VESSEL'S NAME Stl.s.s."GERA" Rpt. Han. No. 15527

The remarks of the Chief Ship Surveyor are desired on this case for the consideration of the Classing Committee.

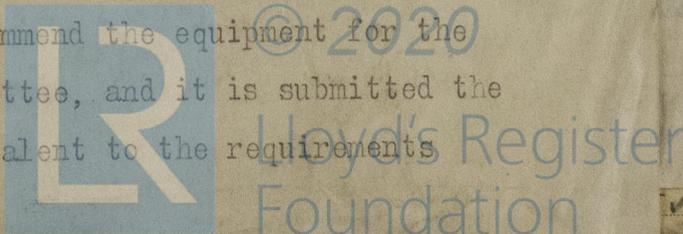
This vessel was originally approved for the class ~~100A~~ "With freeboard" on account of the Owners' desire to dispense with the doubling to the poop deck sheerstrake, but a letter (Copy attached) was received from the Hamburg Surveyors stating that it was decided by the Owners to fit the required doubling.
